Update #1 to the
Technical Drainage Study for

Grand Canyon Village Onsites
Las Vegas, Nevada

W.O. # 8025-2

UPDATE #1
TO THE TECHNICAL DRAINAGE STUDY
FOR
GRAND CANYON VILLAGE ONSITES
CITY OF LAS VEGAS, NEVADA
W.O. # 8025-2
DS #5462

FIGURE 8: ULTIMATE CONDITION
DRAINAGE BASIN MAP

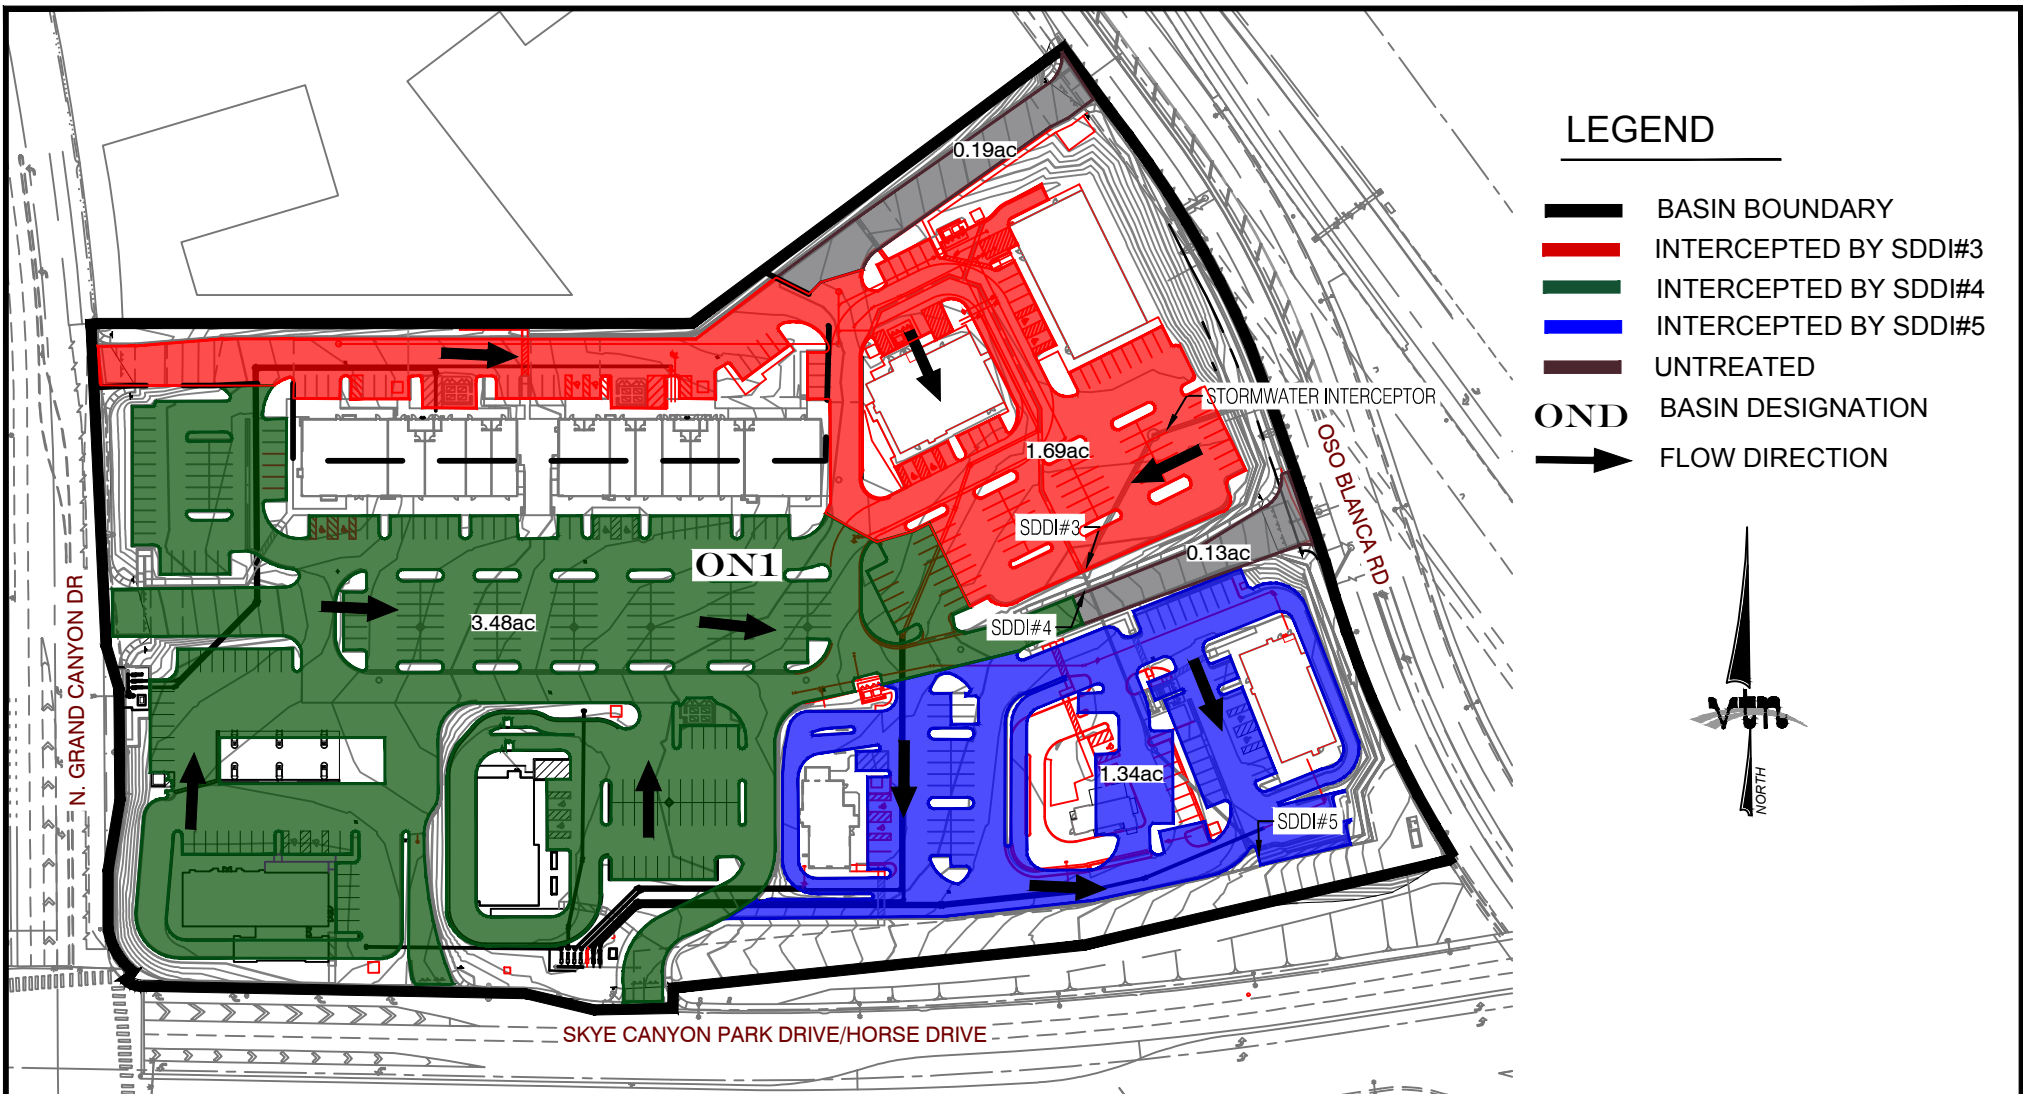
Assumed drainage patterns remain mostly the same as in the initial study, with the exception of the new northeast parking lot and northern drive aisle. As a result, the areas of subbasins ON1B (2/5-cfs), ON1C (1/3-cfs), and ON1E (3/6-cfs) have been revised to match the latest grading plan. However, the change in area of each subbasin was not significant enough to record any measurable change in the previously analyzed flow magnitudes. As such, the overall site flow and discharge patterns proposed within the initially approved study were assumed to be acceptable and remain unchanged. The revised *Figure 8: Ultimate Condition Drainage Basin Map* has been provided in
